## DEFENSE NUCLEAR FACILITIES SAFETY BOARD

Members of the Defense Nuclear Facilities Safety Board's staff recently conducted a review of the Molten Salt Reactor Experiment (MSRE) at the Oak Ridge National Laboratory. The enclosed report documents their observations and is provided for your information.

February 14, 1995

**SUBJECT:** Molten Salt Reactor Experiment: Potential Safety Issues

Figure 2: The Molten Salt Reactor Experiment Auxiliary Charcoal Bed

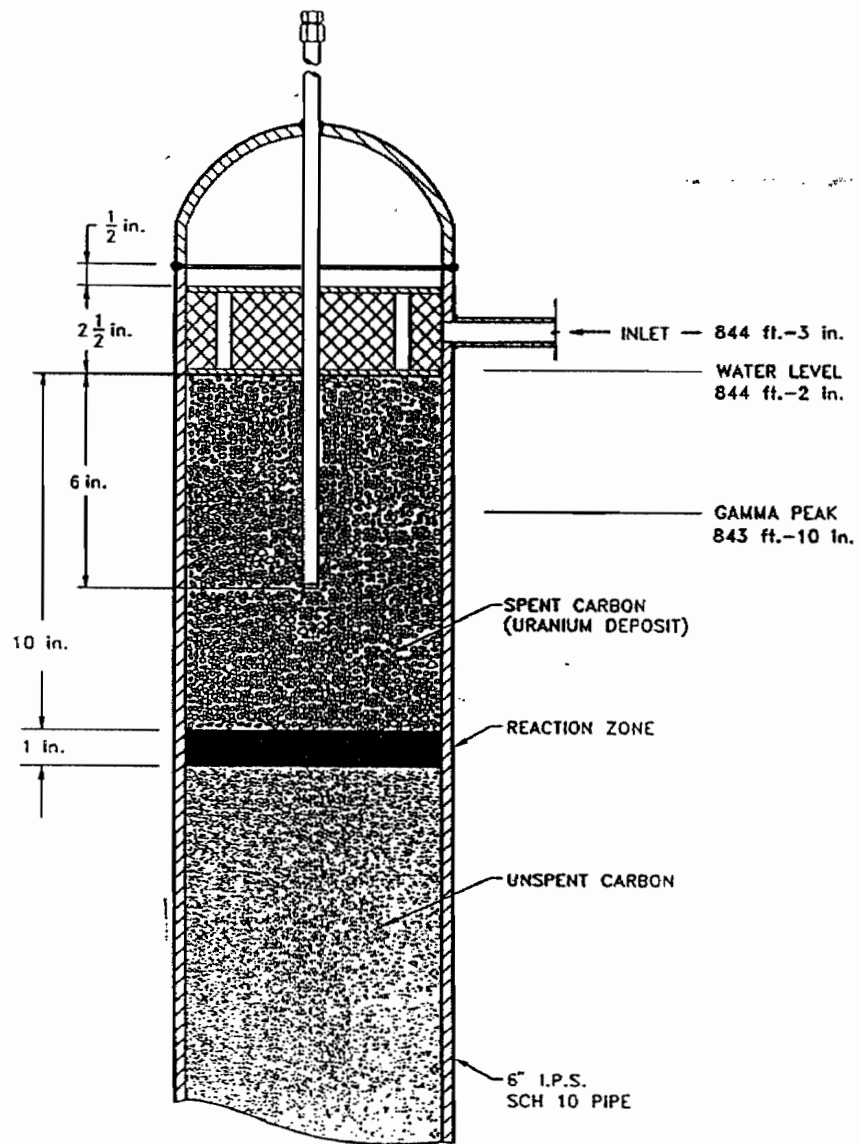
For the ACB,  $\text{UF}_4$  and  $\text{UF}_6$  are mixed with the charcoal. The charcoal acts to reduce the uranium atom density. ORNL examined the potential for a criticality for both water inside the ACB and water outside the ACB. ORNL criticality calculations indicate that the only credible criticality scenario for the 2.6 kg of  $^{233}\text{U}$  is when water enters the ACB and fills the void spaces in the charcoal bed. ORNL calculations also indicate that water reflection alone, i.e., water completely surrounding the outside of the ACB, is insufficient to cause a criticality event. Thus, the current mass of uranium is theoretically sufficient for a criticality, but sufficient moderation is not present. The recent draining of the ACB pit has significantly reduced the amount of reflection.

Figure 3

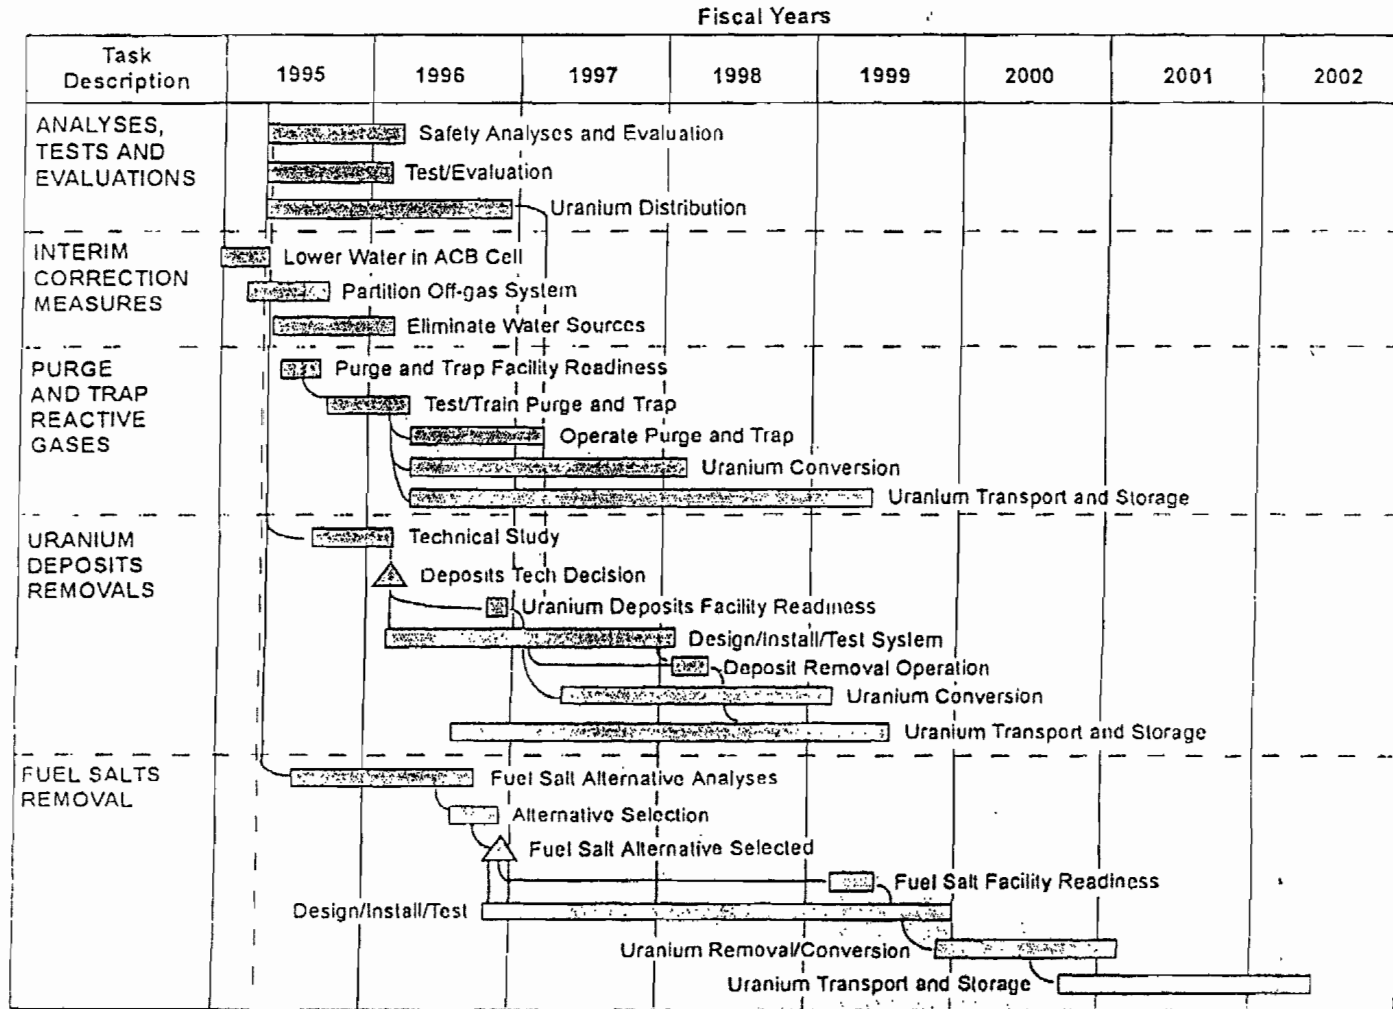
- d. **Programmatic Plan:** DOE and ORNL have established a plan to address the various issues associated with the MSRE. They have near and long term integrated plans for remediation (Figure 3), along with an associated work breakdown schedule (Figure 4). The key issues are funding for this initiative beyond FY1995 and the lack of urgency with respect to the elimination of water sources.
